MARK	REVISIONS	BY	APPR.	DATE
▲	REVISED WILDLIFE FENCE MESH	NCM	ADDEN#3	04/16/2024

**CONSTRUCTION DETAILS**  
**HSIP-GILMAN SPRINGS RD**  
FROM 8,920' S/O ALESSANDRO  
BLVD TO 5,340' S/O BRIDGE ST

ISSUED BY ADDENDUM No. 3, ATTACHMENT "A"

**DETAIL C**  
WALL DRAINAGE

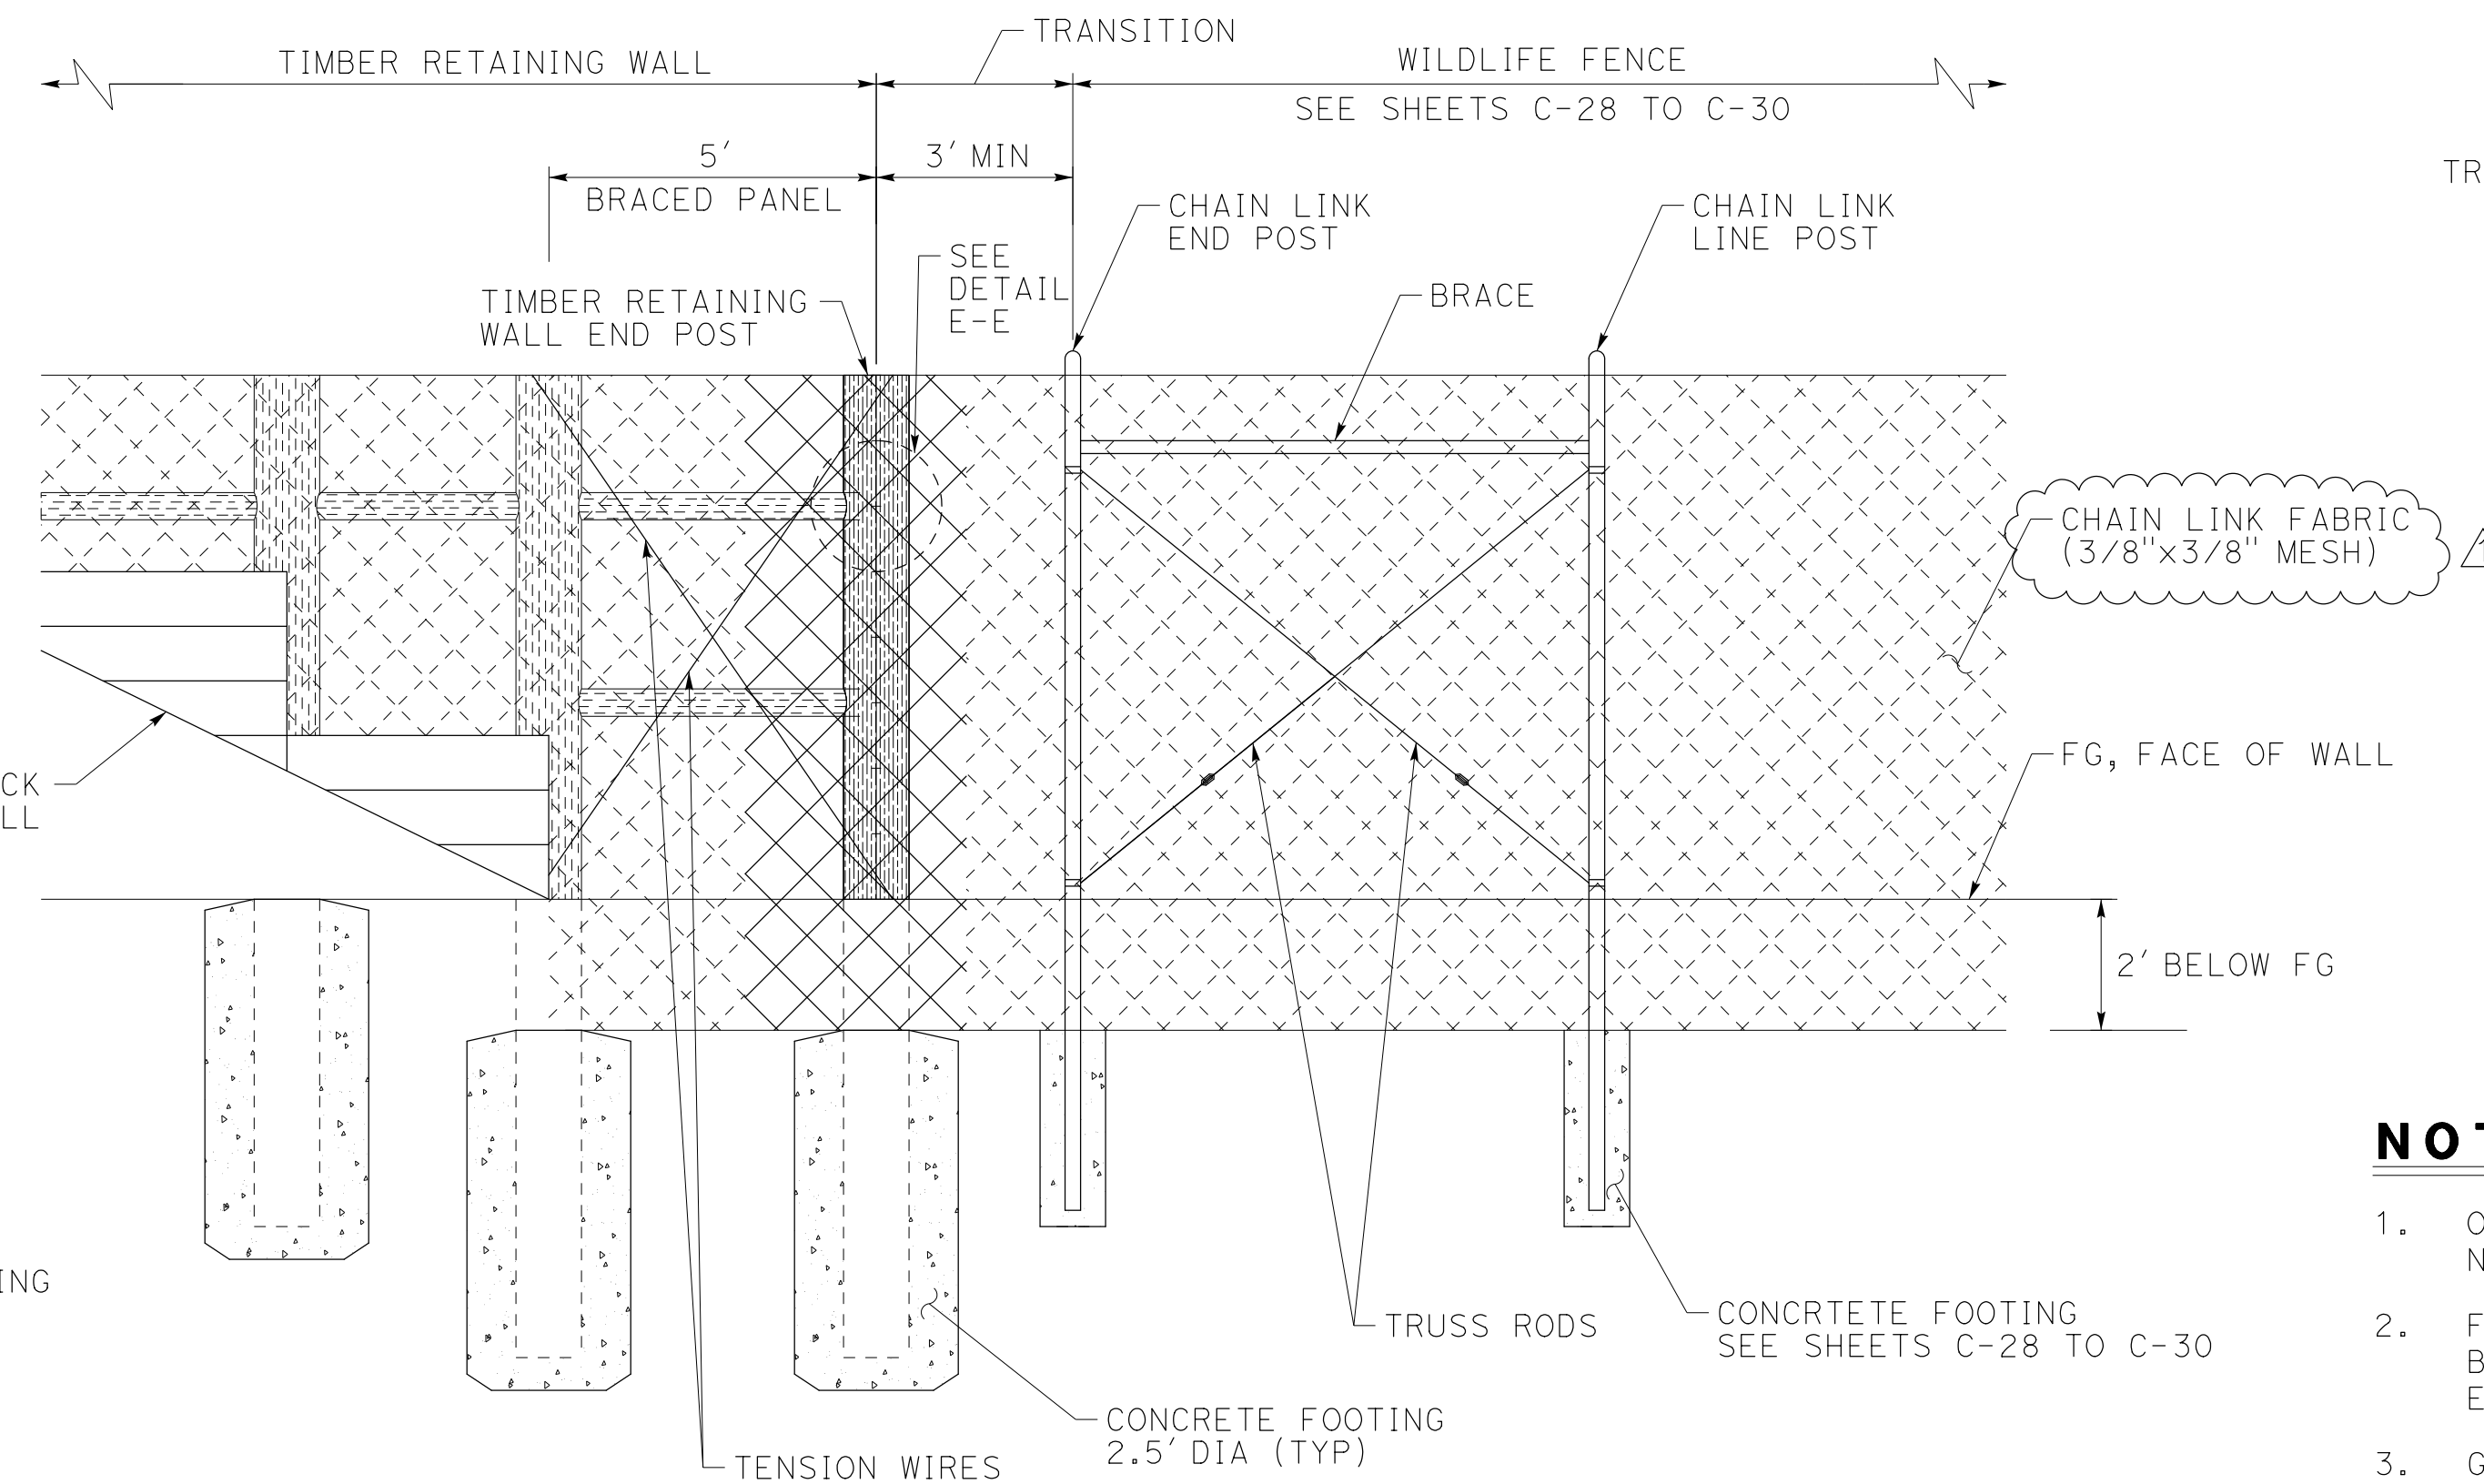
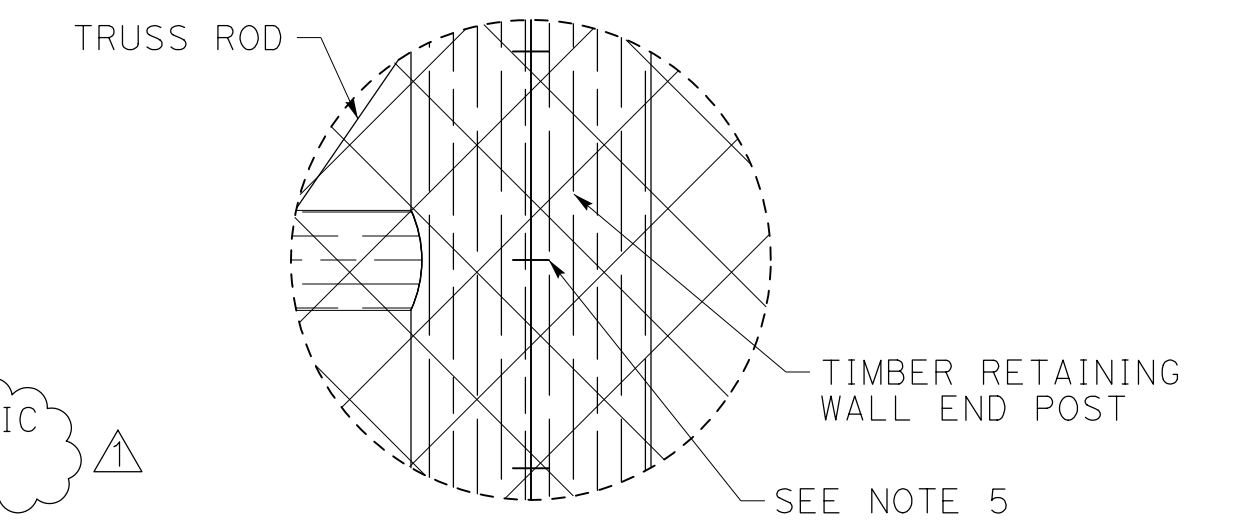
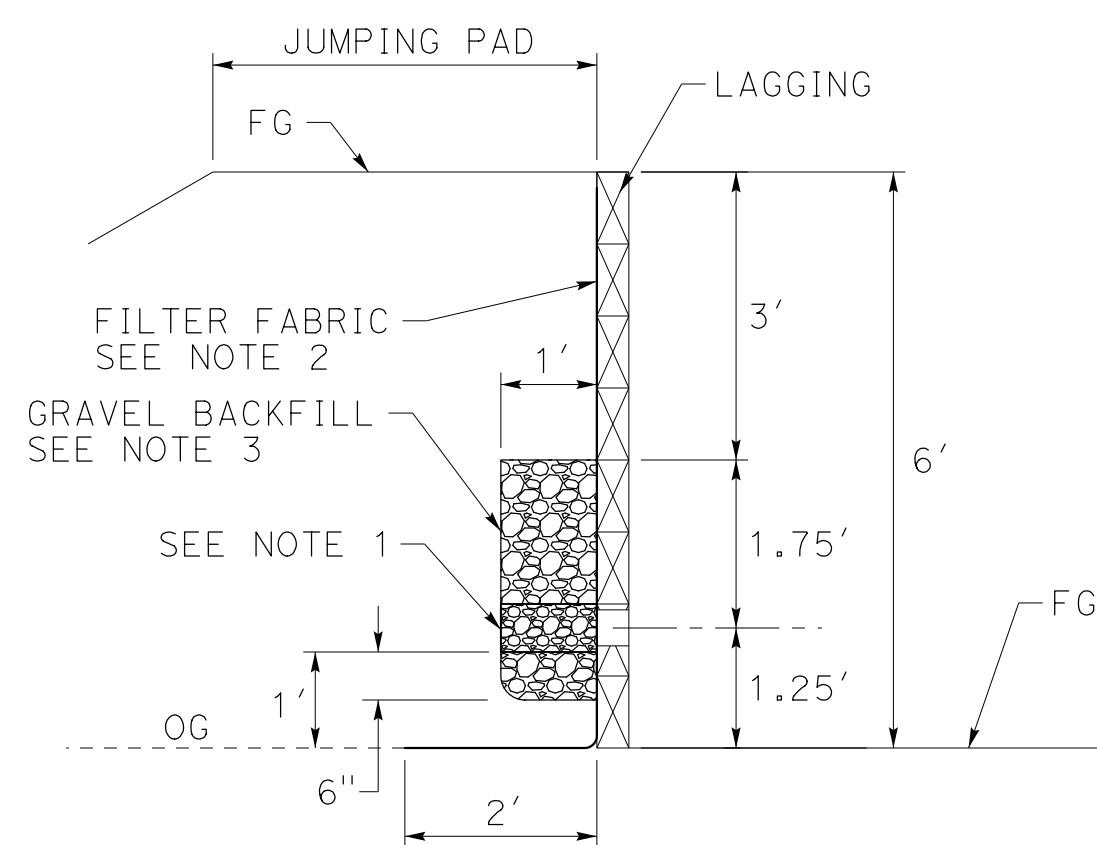
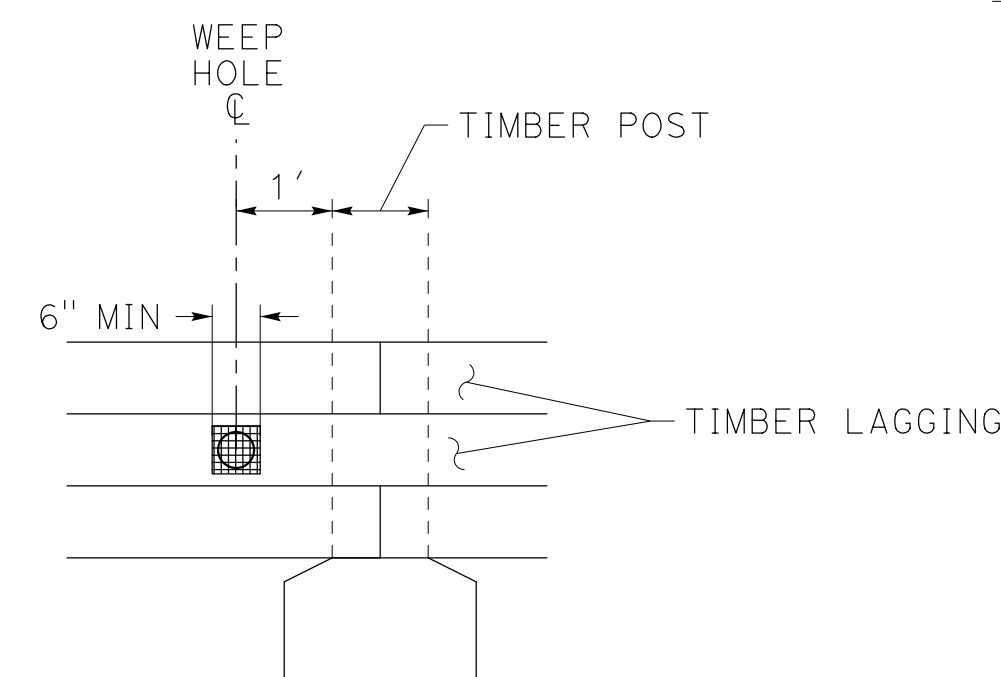
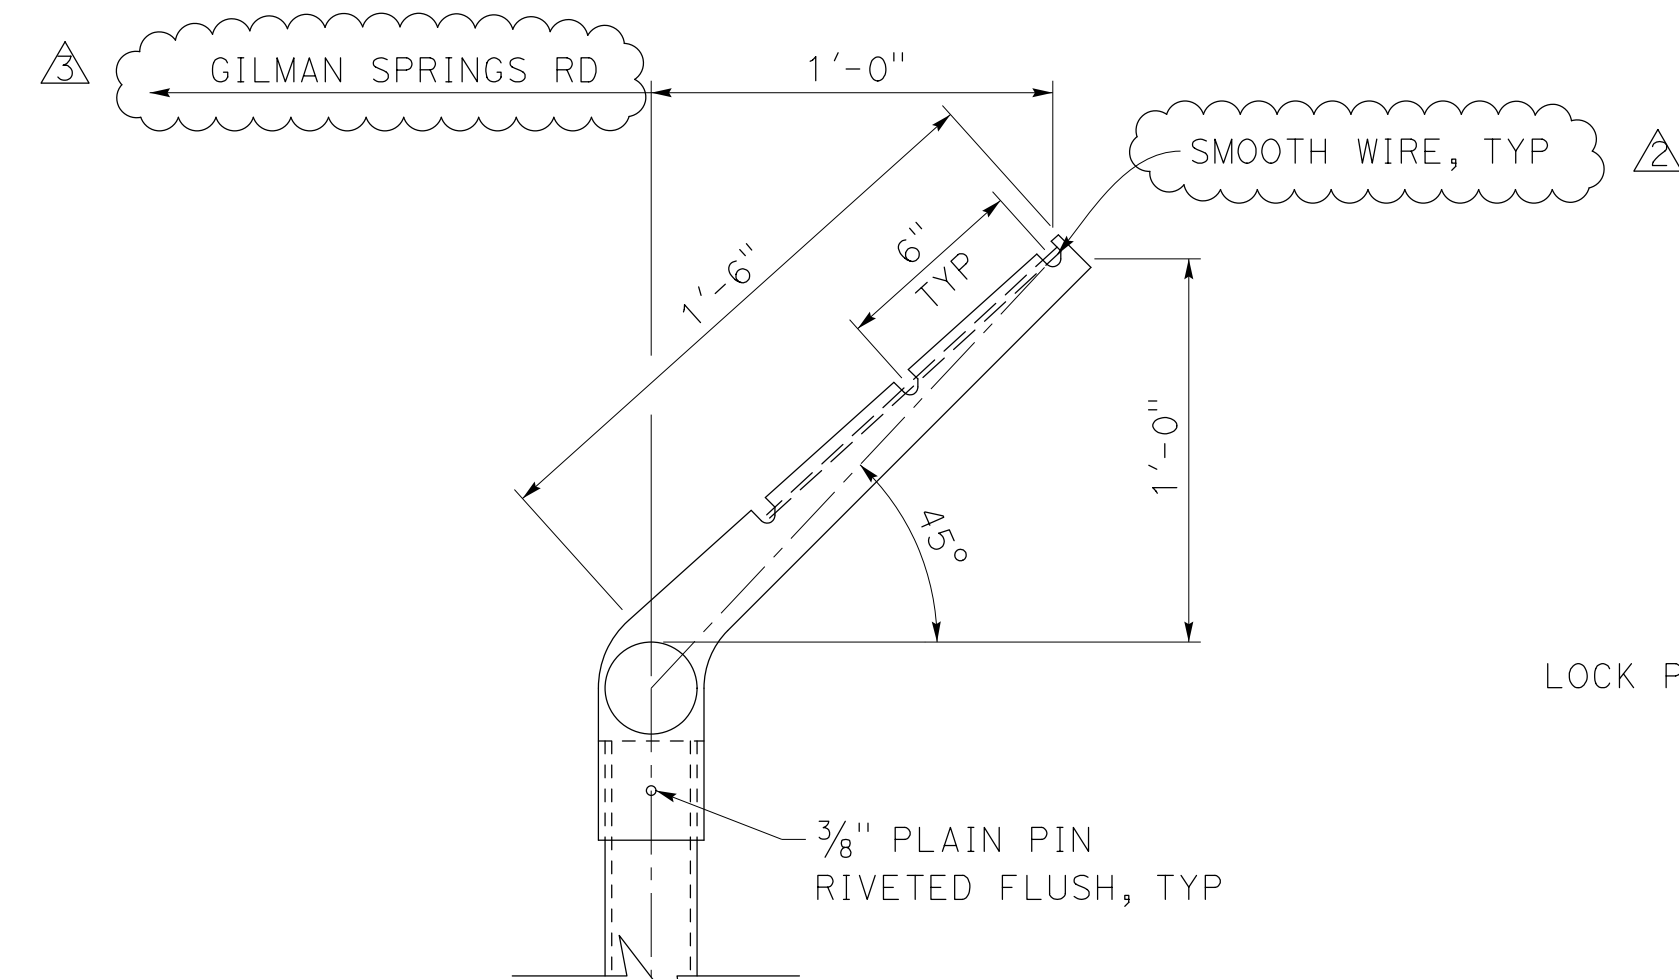
MARK	REVISIONS	BY	APPR.	DATE
▲	REVISED WILDLIFE FENCE MESH	NCM	ADDEN#3	04/16/2024

- ONE CUBIC FOOT PERVIOUS BACKFILL MATERIAL IN NONWOVEN FILTER FABRIC, SECURELY TIED.
- FILTER FABRIC MUST BE SECURELY ATTACHED TO BACK OF WALL WITH NAILS OR AS DIRECTED BY ENGINEER.
- GRAVEL BACKFILL CONTINUOUS BEHIND RETAINING WALL.
- FENCE SHALL BE 3/8" x 3/8" MESH & 9-GAGE (0.141-INCH DIAMETER). ANCHOR FIRMLY TO BACKFACE OF WALL.
- SPLICE OR OVERLAP CHAIN LINK FABRIC AND ATTACH FABRIC TO TIMBER POST WITH GALVANIZED FENCE STAPLES.
